## **NOTICE OF A TYPE II DECISION ON A PROPOSAL IN YOUR NEIGHBORHOOD**

### **CASE FILE NUMBER: LU 13-204756 DZ**

#### **New Deck Area, Fencing, and Exterior Alterations to Existing Building**

Exhibit C-1

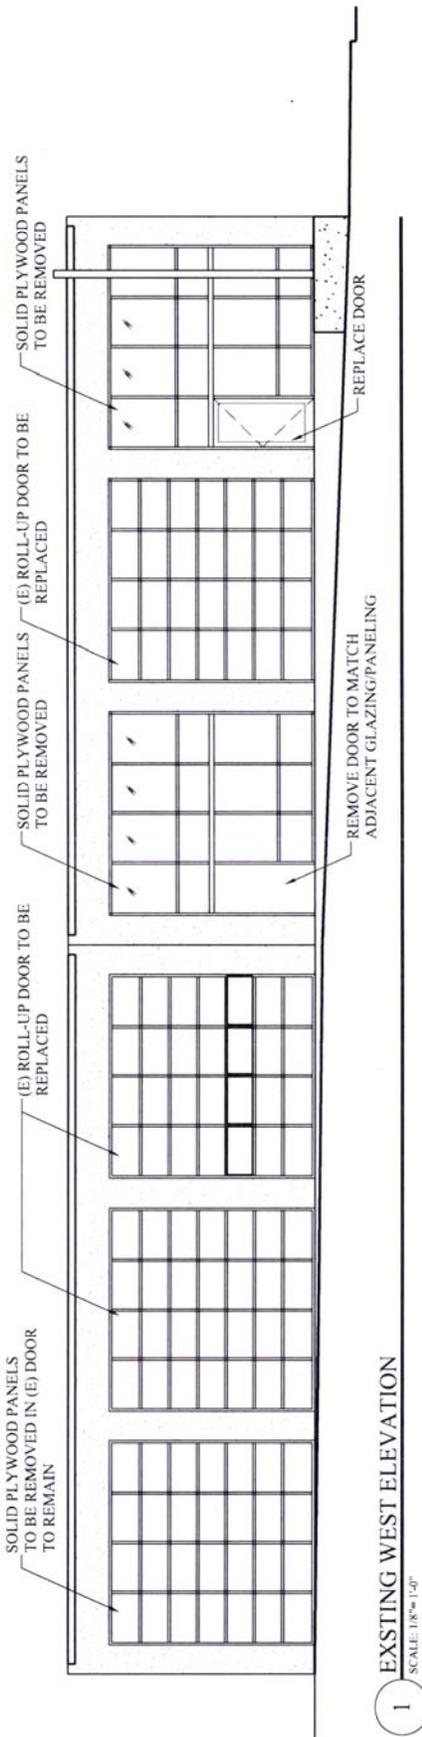
**Neighborhood Review:** No written comments in response to the proposal have been received from the neighborhood association (Buckman Community Association); however, a comment was received via e-mail from Doug Klotz on October 3, 2013. Mr. Klotz expressed concern that some of the proposed construction could be located within the sidewalk right-of-way because the site plan indicated only the “approximate location” of property lines. His e-mail states in part: “Preserving the sidewalk corridor for the use of the public is important...” Exhibit F-1 contains additional details.

**Staff Response:** Mr. Klotz’s concern was shared with the applicant, who then provided a 1970 survey of the site, which shows the location of property lines. Additionally, the applicant added a note to the site plan (Exhibit C-1), as follows: “CONTRACTOR TO VERIFY SOUTH AND WEST PROPERTY LINES BEFORE STARTING WORK.”
